AMENDMENT OF SOLICITATION/MODIFICATION OF CONTRACT

The purpose of this amendment is as follows for Green Brook Sub Basin of the Raritan River Green Brook Flood Control Project Segment R1 Borough of Boundbrook, New Jersey: See attached sheets.

The following have been added by full text:
AMEND # 0001

PROJECT IDENTIFICATION SIGN
MILITARY PROJECT

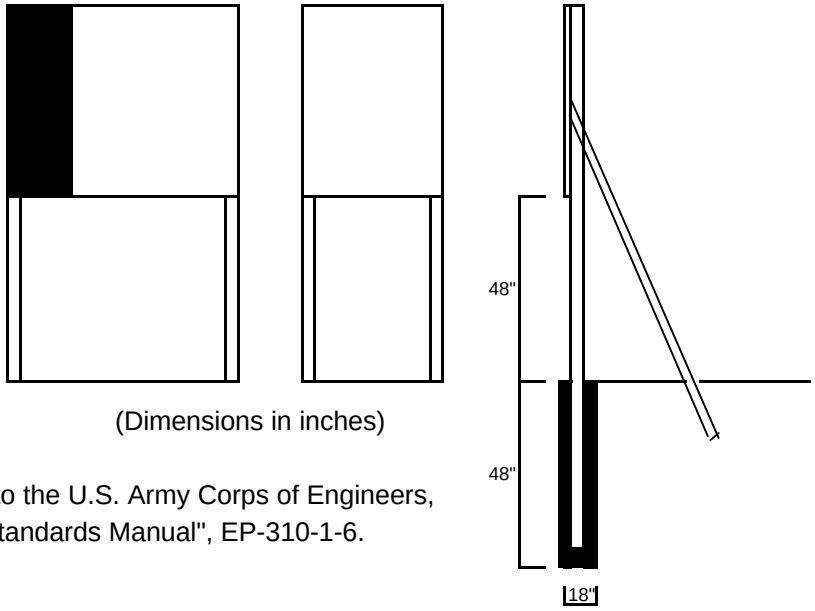
Diagrams of Construction Project Signs and Public Safety Sign for Section 00800 added in amendment.
